Cc:Armstrong, Cassie; Metcalf, Megan A.Subject:Comments re: 21-OVERLAY-0031Date:Monday, December 13, 2021 12:30:46 PM

I am writing in response to 21-OVERLAY-0031 regarding an overlay permit request for 1270 Bardstown Road, at the corner of Bardstown Road and Rosewood Avenue. Please add this letter into the record for this case, and please share this letter with the Bardstown Road Overlay District Committee.

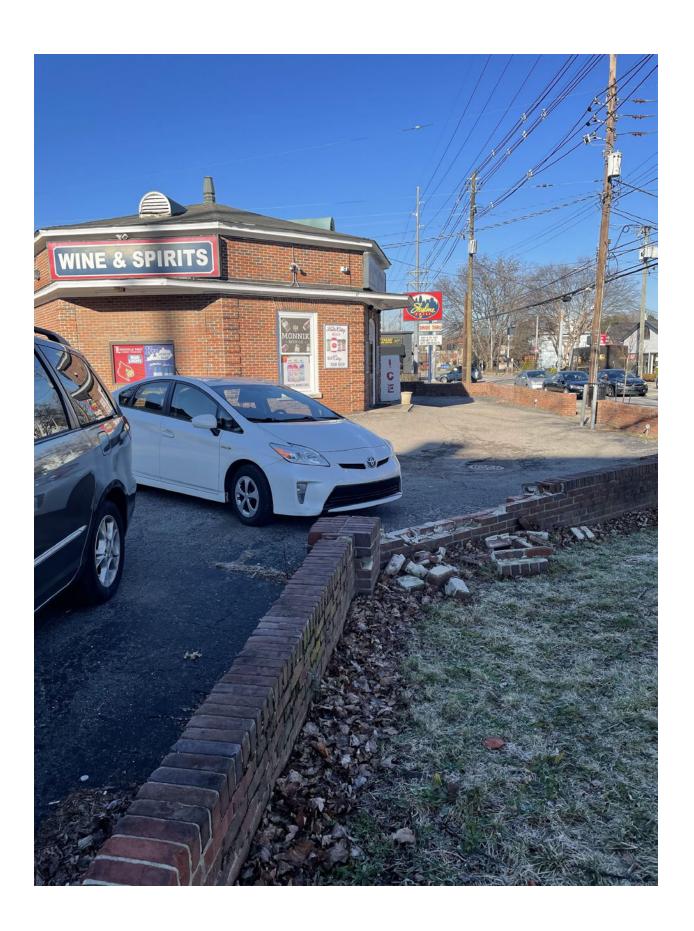
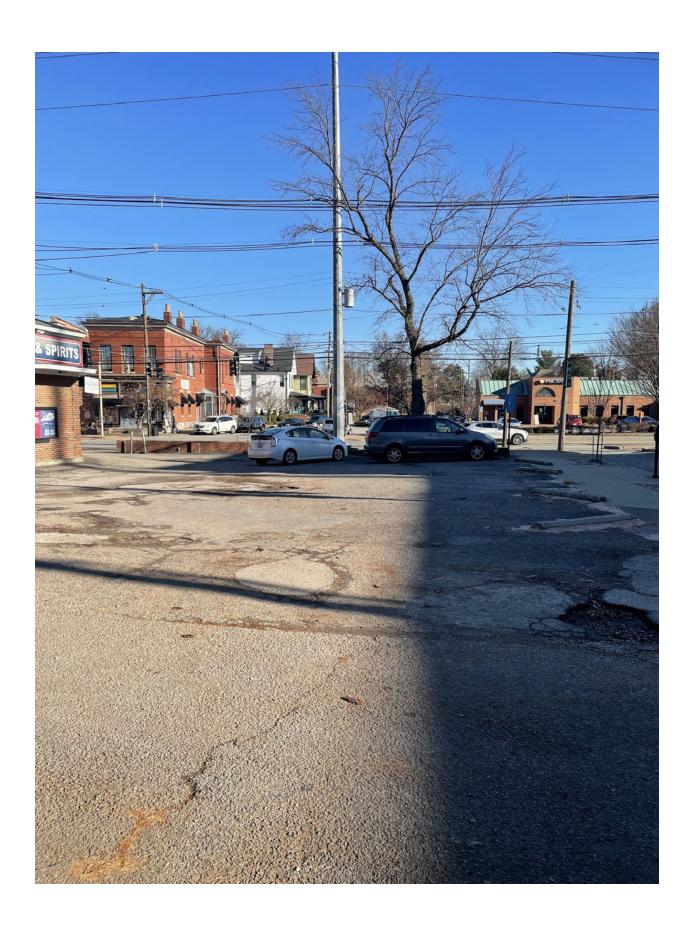
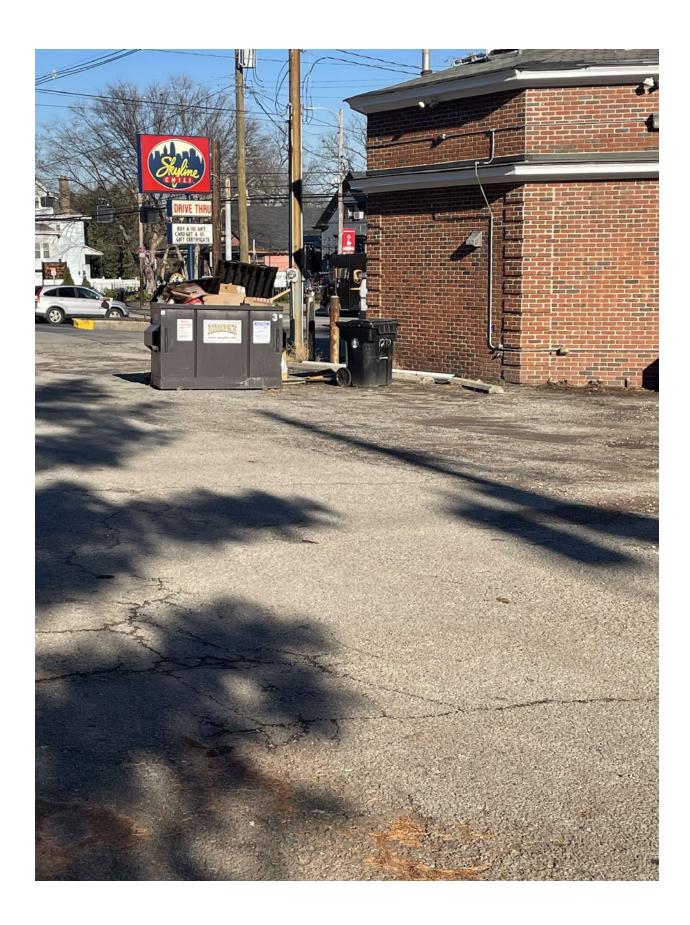
You could say the same thing about the stretch of Bardstown Road unregulated by pedestrian-favoring guidelines past the Watterson. Carcentric planning is really a lack of pedestrian forethought. The site plan reflects this. This block is already drive thru saturated, with three on this site alone and two across the street, and is the salient example that led to negating drive thrus altogether In Nulu.

Never mind how many drive thrus were removed altogether or completely shielded from the street in the past 30 years. Never mind how any existing drive thru was minimized by superior design criteria and exceeded the standards of the existing guidelines. Never mind this business already asked for this same thing years ago and was told no. Traffic engineering principles alone should tell you that! Three merging drive thrus with zero wayfinding into a right turn only exit at a major pedestrian crossing! The main pedestrian entrance to the business crosses said drive thru, and a dumpster is proposed at the Rosewood access blocking visuals to Rosewood......what could go wrong?!

A major focus of the overlay guidelines is minimizing curb cuts. Why? Because pedestrians don't do so well crossing them! Ben Botkins' recent redo of the police station/ballet building includes removal of the existing driveway. When the Eagle in the same block was renovated for a prior restaurant we did the same; removed the mid block driveway and turning it into outdoor seating. Commonwealth Bank replaced a fast food business. It's lushly landscaped site belies the fact there is a drive thru at the rear. The recent La Bomba rebuild, (a business with one of the most dangerous drive thrus on the corridor), completely eliminated the drive thru. A site plan that requires a waiver and a variance from the LDC gives me flashbacks of the Goodfellas pizza case, a case so botched by poor review order (BOZA ahead of overlay) and a site plan so devoid of proper analysis, the case, after four hearings, was summarily rejected. Rightly so. Any time a site plan shows fifty surface parking spaces ahead of the building, with an ill-defined pedestrian access through said parking, at a major intersection with zero attention to said pedestrians, AND creates a blind access singular drive aisle crossing the pedestrian sidewalk from the street......well. It's either aTMC form or its not. The applicant crawled away.

The purpose of design review and zoning is to better the outcome and bring a pedestrian corridor's development into better compliance with the code. The design record of this corridor proves you can have superior, highly designed, pedestrian friendly development. Curb cuts and drive thrus were never the focus of the development plan or the outcome. When Rally's was demolished for Just Fresh across from mid city, a drive thru-less restaurant with terrace was designed. Although now a paint store, adaptive reuse will again come and the building is poised, by virtue of its design, to be a restaurant once again. I have no idea what purpose an

outdoor patio at the corner of an already traffic challenged side street serves. I guess I should be grateful for that tree, which will

likely perish from the proposed changes. How about simple landscape enhancements?! Every tree planted as part of the 1996 Baxter Ave Theatre project has died or been cut down from lack of maintenance. Canes removed mature healthy trees for vertical sticks so you could see their overscaled sign. Win win.

Finally, that's not an existing drive thru window. Just like Krogers wasn't. The broken up paving, junk strewn on site, and parking that can only be described as wonky, a falling in wall and poorly maintained, but still alive tree complete the picture. A lousy neighbor to have. The "improvements" proposed aren't any better than the sad lack of maintenance currently.
